# Morrison's Island

Public Realm and Flood Defence Project

## Response to Request for Further Information

11 July 2019

**Figure 1: Modelled flood extents for a 1 in 100 year tide scenario (combined with a 150m<sup>3</sup>/s Inniscarra Discharge)**

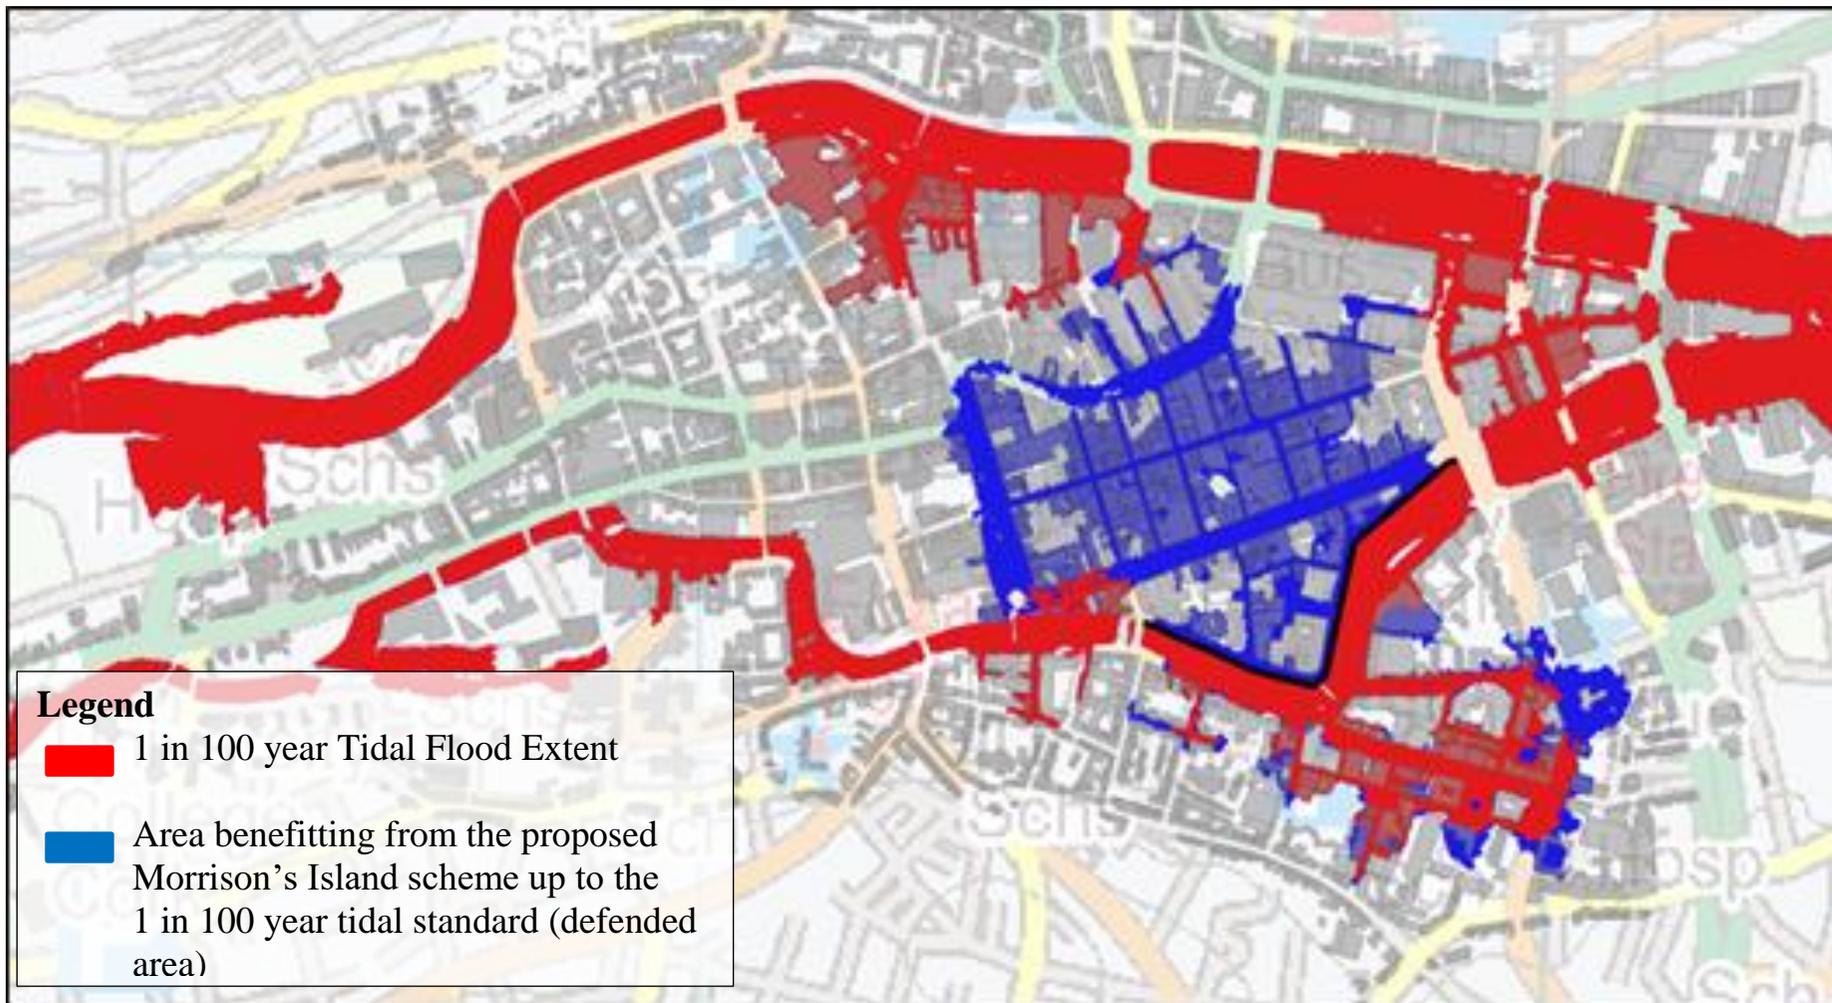
- The flood defences at Morrison's Island provide significant flood alleviation benefits up to the circa 1 in 100 year tidal standard (refer to figure 1 below). The modelled peak flood level in the channel at Morrison's Island in this event was circa 2.9mOD. (Note that this is equivalent to the peak level of the major tidal flood event of January/February 2014).

All of the above benefits would be delivered by the Morrison's Island project alone, i.e. without the LLFRS in place.

**Figure 3: Pinch Points Key Plan**

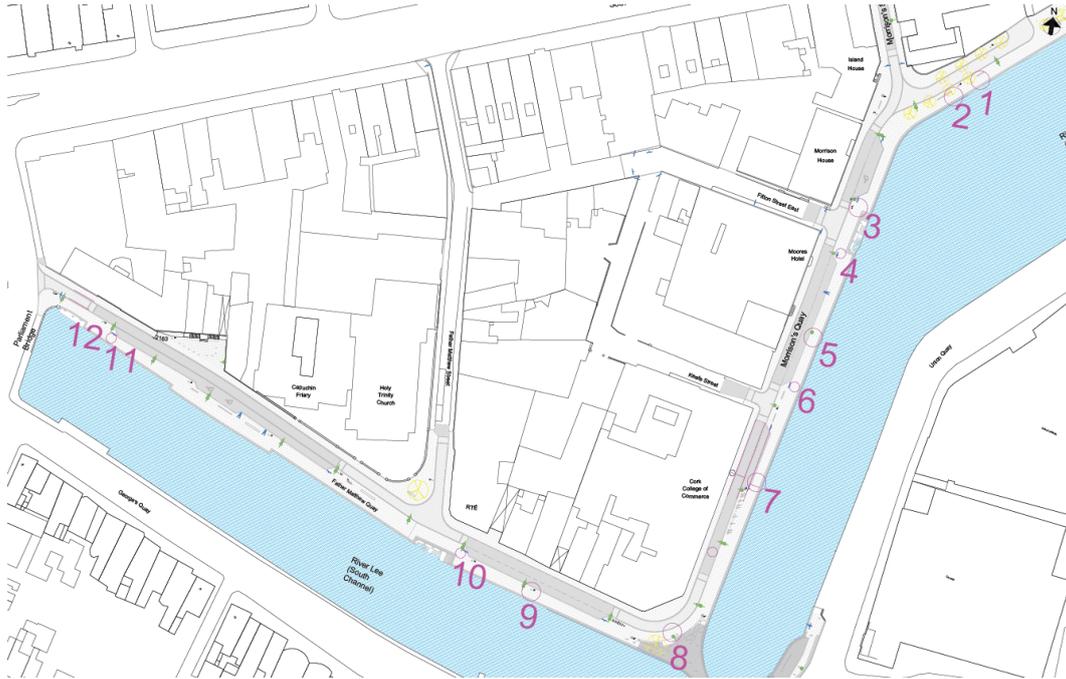
The proposed layout as submitted for planning permission was re-examined in order to identify any pinch points on the shared pedestrian / cycle path whereby the effective width was reduced to below 3.05m.

In total 12 no. locations were identified where the effective width of the shared path was below 3.05m. Of these 12 no. locations, 2 no. were as a result of proposed seating, 2 no. were due to proposed Litter bins, 2 no. were due to proposed public lighting columns, 2 no. were due to the road alignment / cross-section and 4 no. were due to proposed sign poles.

However, one pinch point remains, relating to a proposed lighting column located opposite Moore's Hotel (ref location 5 on **Figure 3**). A number of options were considered including:

Minor rearrangement of proposed street furniture in the affected areas permits the removal of 11 of the 12 no. pinch points.

The design team proposes, with the permission of An Bord Pleanála, to retain the proposed lighting column in its location which results in a pinch point with an effective width of 2.75m between the column and the flood defence wall. As a localised pinch point, it is considered that a one-off reduction in effective width will not compromise the overall scheme and the purpose of the shared path.
